Detailed Site Plan Remand Hearing Checkers Laurel

DSP-20006

SUBJECT: Detailed Site Plan DSP-20006 (Remanded)
Checkers Laurel

REVISED PLANS

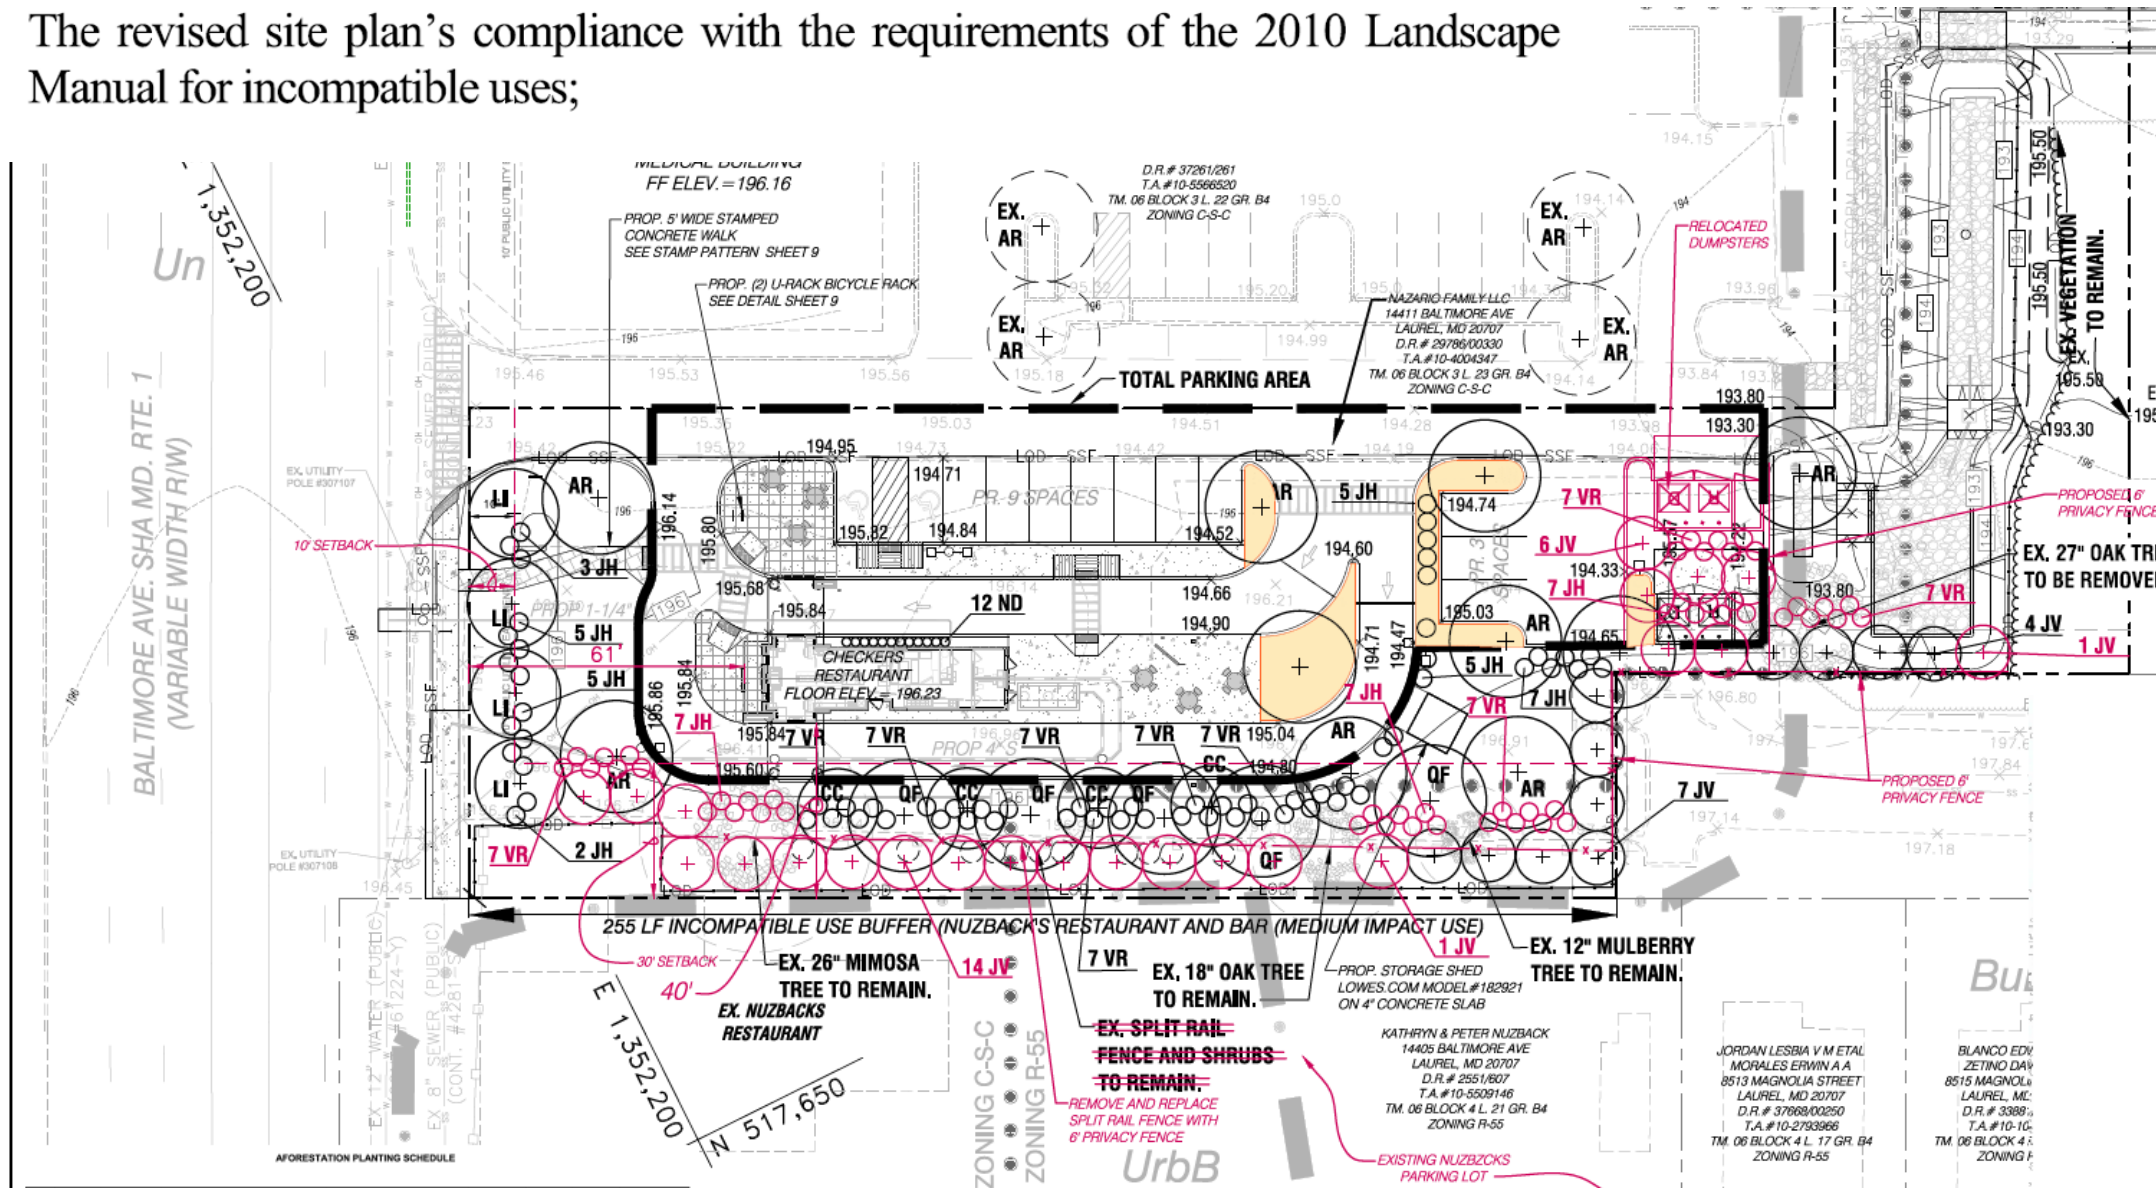
- The revised site plan's compliance with the setback requirements of the C-S-C zone;

The applicant’s revised DSP shows a setback from the street of 60 feet, which exceeds the 10-foot setback requirement. Landscape buffers for the side and rear yards are required to be 30 feet wide, which is greater than the 12-foot side yard and 25-foot rear yard setbacks otherwise required by Section 27-462(b). The revised DSP shows landscape buffers of at least 40 feet in width are provided, which is in excess of the requirements of Section 27-462(b). Therefore, the application meets all setback requirements of the C-S-C Zone as shown on the revised site plan.

REVISED PLANS

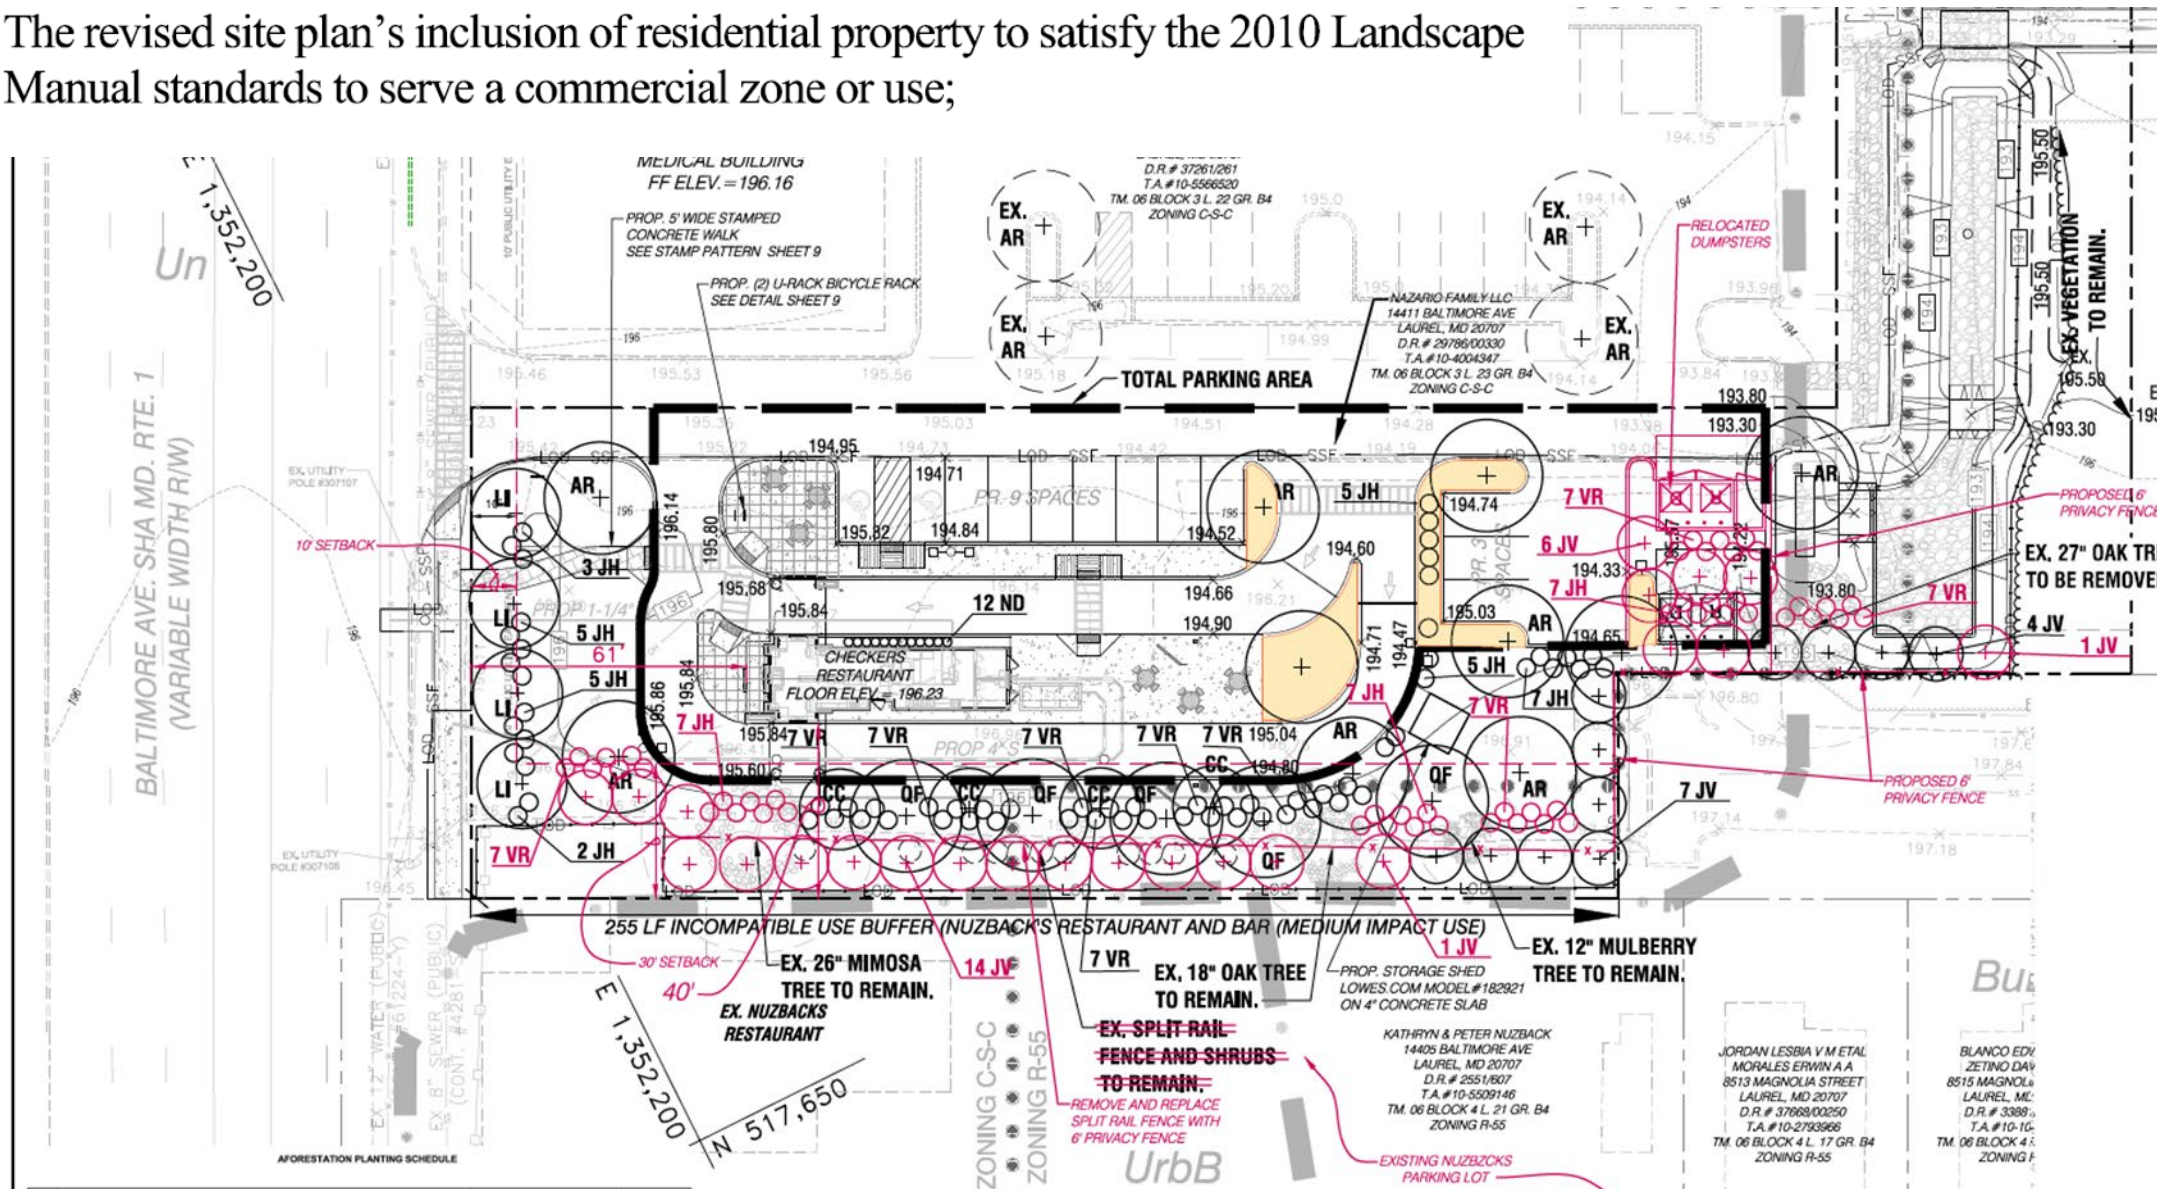
- The revised site plan's compliance with the requirements of the 2010 Landscape Manual for incompatible uses;

The Section 4.7 bufferyard provided with the revised landscape plan exceeds all minimum requirements. A 40-foot building setback and 27-foot-wide landscape yard is provided. Minimum plant unit requirements have been exceeded as well. The landscape plans show 22 percent of the bufferyard vegetated by existing non-invasive trees and a six-foot-high, sight-tight fence is provided. With the existing vegetation and fence, the minimum number of required plantings within the bufferyard could be reduced to 79 plant units. However, the landscape plan provides 207 plant units, which exceeds the minimum quantity required, without counting reductions for the existing non-invasive vegetation and fence. The design of the bufferyard, including fence location, plant species selection, and planting locations are acceptable. All requirements of Section 4.7, Buffering Incompatible Uses, applicable to this bufferyard have been satisfied, with all minimum requirements exceeded.

Regarding the eastern property boundary shared with Lot 12, the revised plan provides for the continuation of the six-foot-high, sight-tight fence, retention of existing vegetation, and installation of 29 shrubs. As provided by Table 4.7-2 of the Landscape Manual, a Type ‘D’ bufferyard is required in this location with a 50-foot building setback and 40-foot landscaped yard planted with 160 plant units per 100 linear feet. The revised plan does not provide a landscape schedule to demonstrate conformance with the applicable requirements in this location. A condition is recommended for the required landscape schedule to be shown on the plan. If conformance cannot be demonstrated, the applicant may request alternative compliance, in accordance with Section 1.3 of the Landscape Manual.

REVISED PLANS

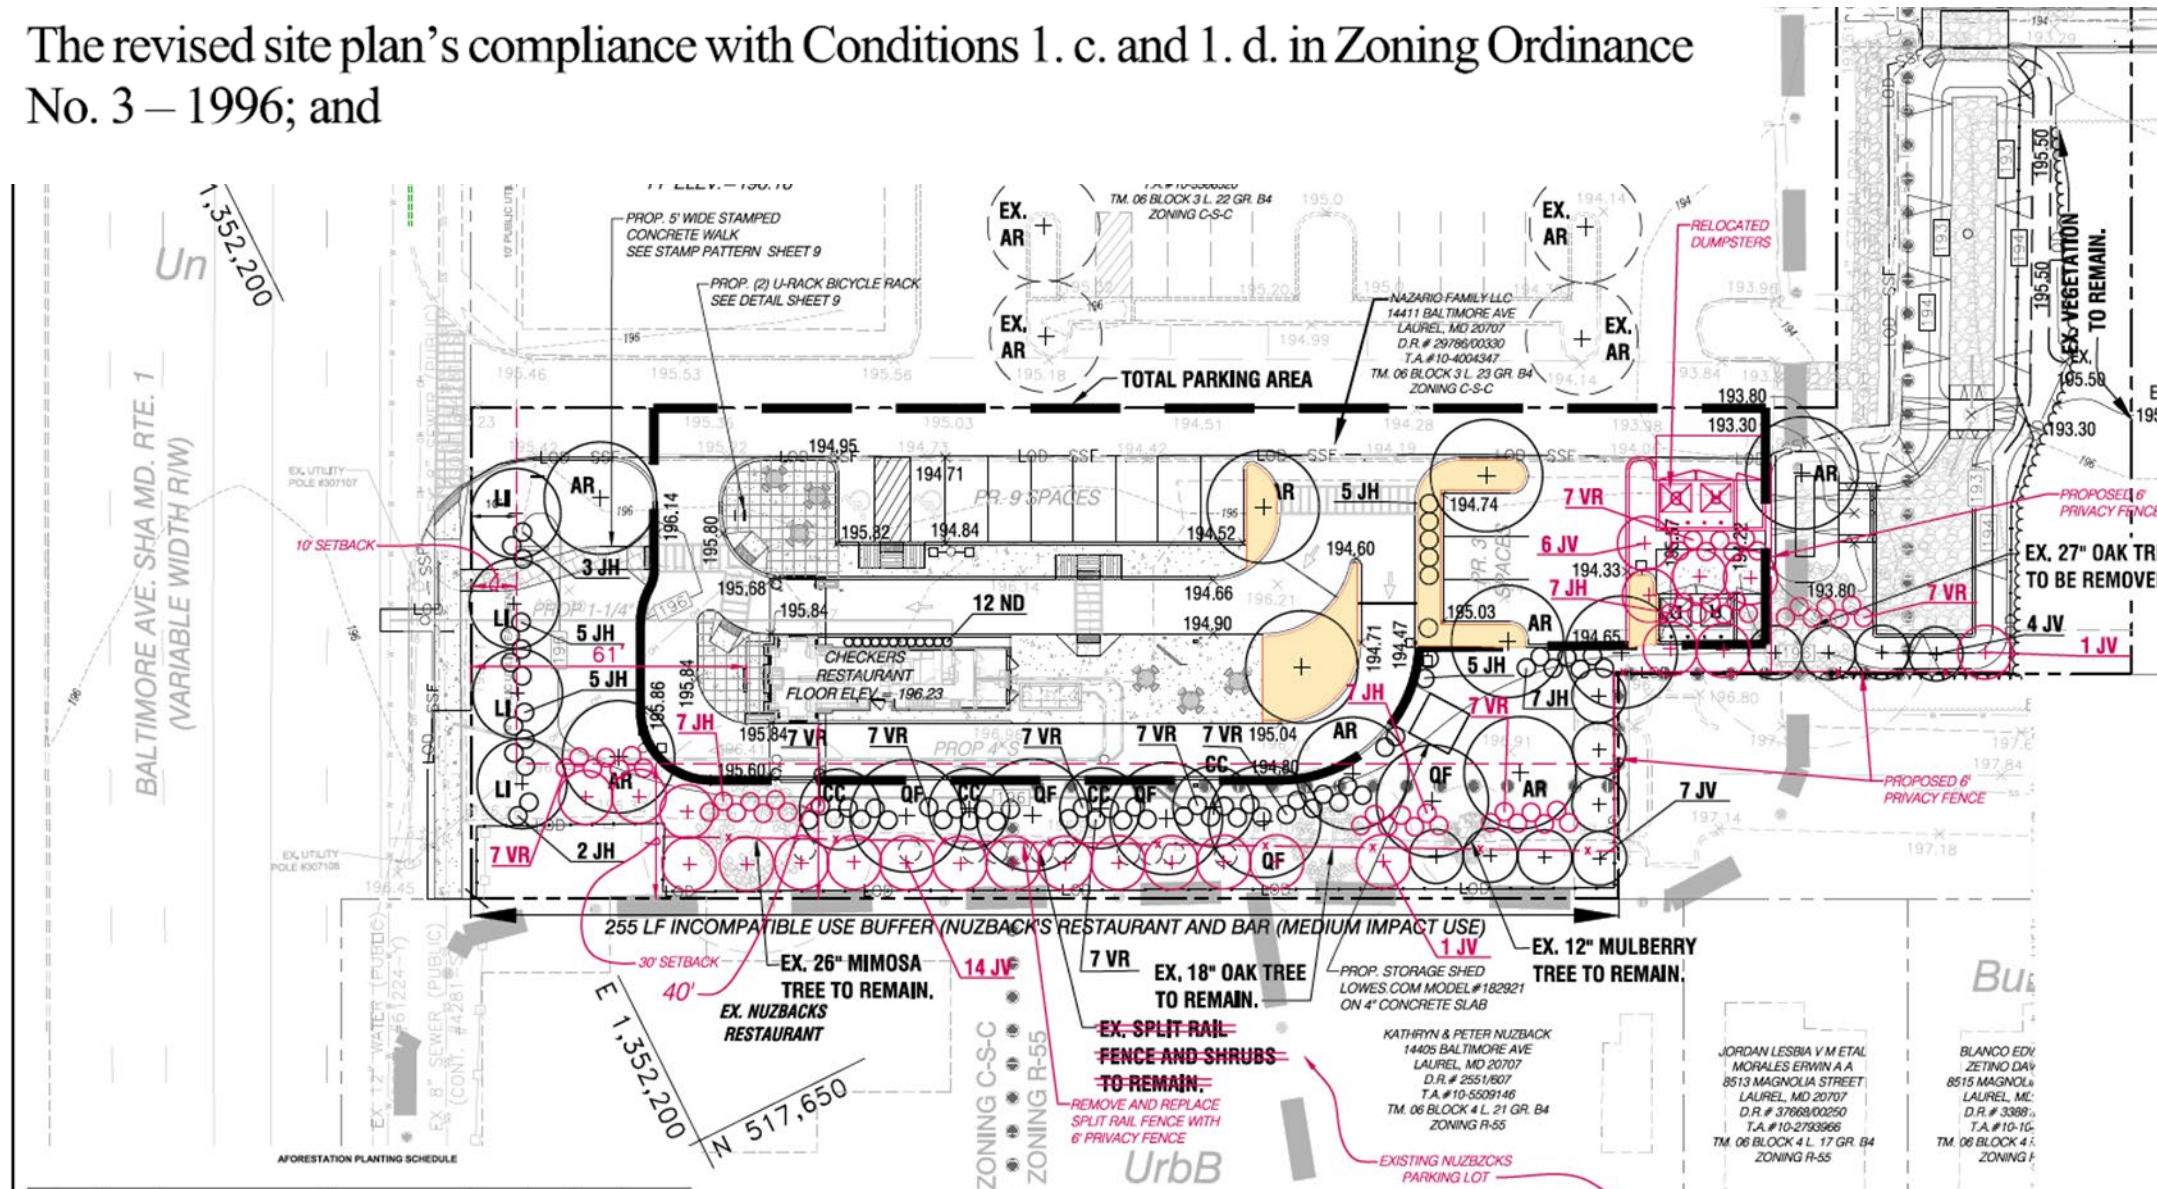
4. The revised site plan's compliance with Conditions 1. c. and 1. d. in Zoning Ordinance No. 3 – 1996; and

The landscape plan shall also show the preservation of the large tree shown on Lot 10 of the applicant's survey of January 1994, if feasible.

The original DSP, and revised materials submitted in response to the Order of Remand, provide a discussion that indicate the large tree shown on Lot 10 of the applicant's January 1994 survey is not feasible to preserve.

Staff concurs with the applicant's rationale that preservation of this specific tree is not feasible, as it has already been previously impacted by paving on the property, which covers a large portion of the tree's root zone. Any redevelopment of the property to remove or resurface this existing paving, in order to implement current SWM regulations, will involve a large impact to the root zone and require an unreasonable amount of protection to ensure the viability of the tree. Allowing an impacted tree such as this to remain would create a potential hazard should it die and fall onto the adjacent commercial or residential properties.

In addition, the general area of the large tree on Lot 10 is proposed to be planted with 11 evergreen trees and 21 shrubs. While the preservation of this specific tree is not feasible, the landscape plan provides for these replacement plantings and the preservation of other large trees on the site, which is appropriate. Staff finds that the applicant's revised submission satisfactorily addresses this requirement.

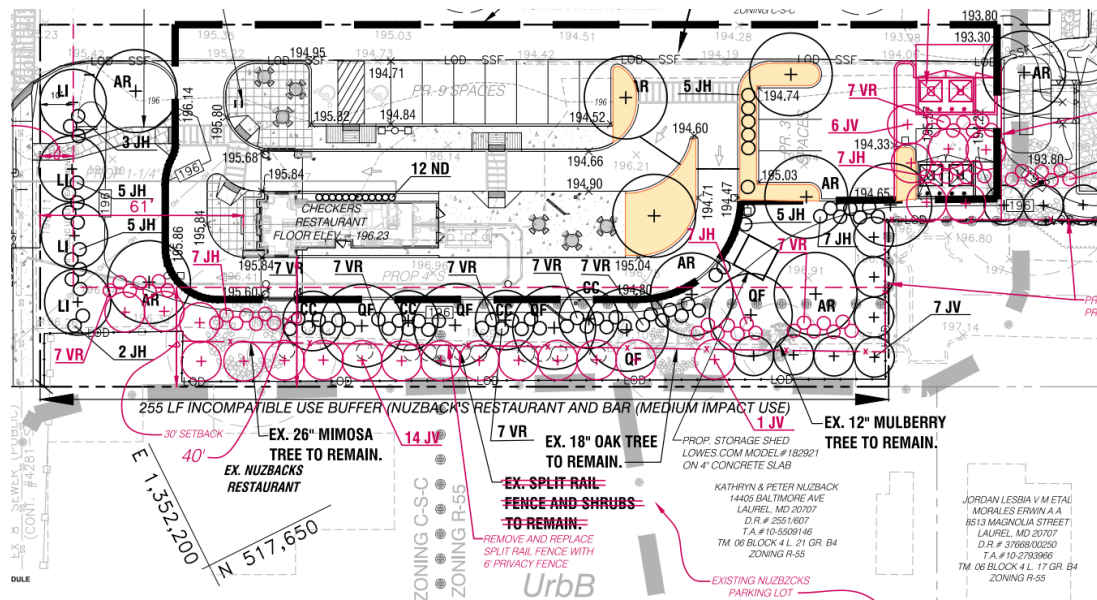
2. The revised site plan's compliance with the requirements of the 2010 Landscape Manual for incompatible uses;

RESPONSE: All requirements of the 2010 Landscape Manual¹ are met. Specifically, and as provided on the revised DSP, all required bufferyards, building setbacks, and landscape strips for the required 4.2 and 4.7 Schedules are provided. Indeed, and to be more responsive the District Council's Order of Remand, the applicant has made a number of revisions to the DSP and Landscape Plan.

Section 4.7-1(G) of the Landscape Manual provides that “[i]n the case of a lot that is located in more than one zone, the establishment of the required bufferyard is based on the platted or recorded property line(s), not the zoning line(s).” The property within the boundaries of DSP-20006 is owned by Nazario Family, LLC, so an easement to accommodate any additional or required landscaping in any bufferyard is not required. Although the applicant does not believe that alternative compliance is required, if it is, the applicant respectfully requests the same, as the proposed bufferyard and landscape strips (either 4.7 or 4.2) are equal to or better than normal compliance. As provided on the revised plans, the 4.7 bufferyard along the southern boundary includes a building setback that is (10) feet wider than what is required; a landscape yard that is seven (7) feet wider than what is required; a six-foot high privacy fence; and plant units that exceed the requirement.

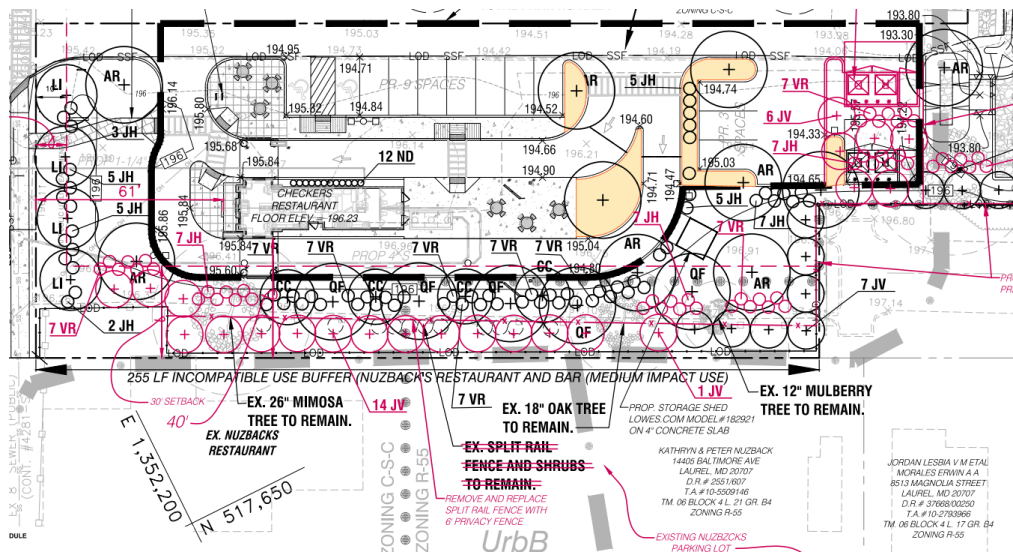
The landscape plan shall also show the preservation of the large tree shown on Lot 10 of the applicant’s survey of January 1994, if feasible.

successfully; reasonable; likely.”² The preservation of this particular tree is not reasonably likely nor could it be dealt with successfully. Given the prior development of the subject property that extended to the tree in question, this tree was previously damaged by the urban environment and development. In particular, the subject property was the former site of the Bay and Surf Restaurant and associated parking lot, which extended to and over the root zone of said tree.

It would not be reasonable to preserve this tree, as it would require significant protection of the root system to ensure its continued viability, which would result in unreasonable costs and would substantially detract from the utility of the proposed development for its intended use, which is permitted in the C-S-C Zone. In response, however, the applicant’s landscape plan provides for the preservation of several other large existing trees in the same vicinity of the site, as well as the addition of new trees. The revised DSP and Landscape Plan now show 11 new trees being planted in the same area of the tree in question. Consequently, and notwithstanding the necessary removal of this tree, the applicant’s design more than doubles the required Tree Canopy Coverage requirement (3,659 square feet is required, and 8,411 square feet is provided).
